**Pacific Gas and
Electric Company®**

PG&E Letter DCL-09-086

Diablo Canyon Units 1 and 2
Docket No. 50-275, OL-DPR-80
Docket No. 50-323, OL-DPR-82

License Amendment Request 09-06, Critical Damping Value for Structural Dynamic
Qualification of the Control Rod Drive Mechanism Pressure Housings

Figure 1

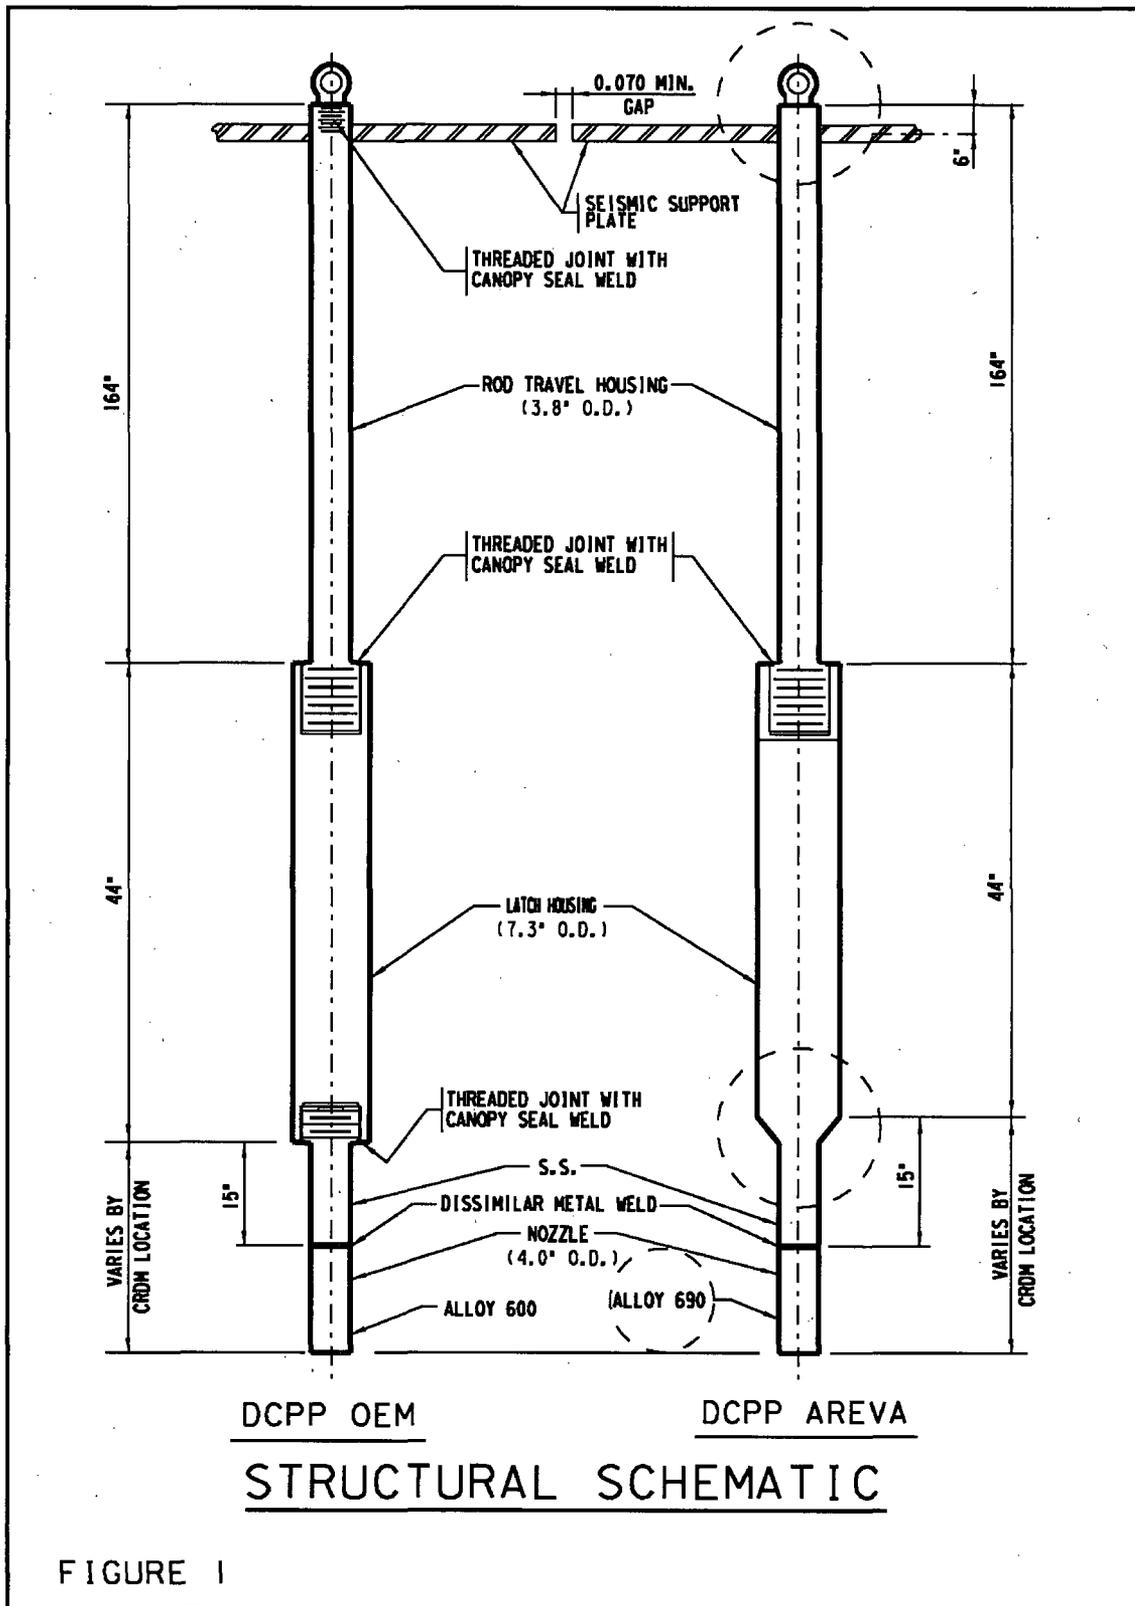
The following provides the basis of similarity between the OEM CRDM and the AREVA-supplied CRDM, as depicted in Figure 1:

1. *Gap at the seismic support plates.* The CRDM testing that supports the 5 percent damping value was based on a seismic support plate gap of 0.060-inch. The seismic support plates / seismic support structure for the replacement CRDM design provides a 0.070-inch (cold)/0.100-inch (hot) gap between the CRDM seismic support plates, consistent with the gap between the OEM CRDM seismic support plates.

7. *Specific design differences.* The design enhancements are shown in the circled areas in Figure 1. Alloy 690 is substituted for Alloy 600 for its superior resistance to PWSCC. These materials' physical properties are equivalent and with no change in the effect on damping. Threaded joints with canopy seal welds at the top and lower positions have been eliminated in favor of one-piece construction. The OEM fine-threaded joint connections are pressure-loaded and designed to minimize or eliminate relative displacement between the joined parts; therefore, any difference in damping effects of these joint connections and the one-piece design are negligible.

Therefore, based on the similarity of the AREVA-supplied replacement CRDMs to the OEM CRDMs, 5 percent critical damping is a conservative value to use for dynamic analysis.
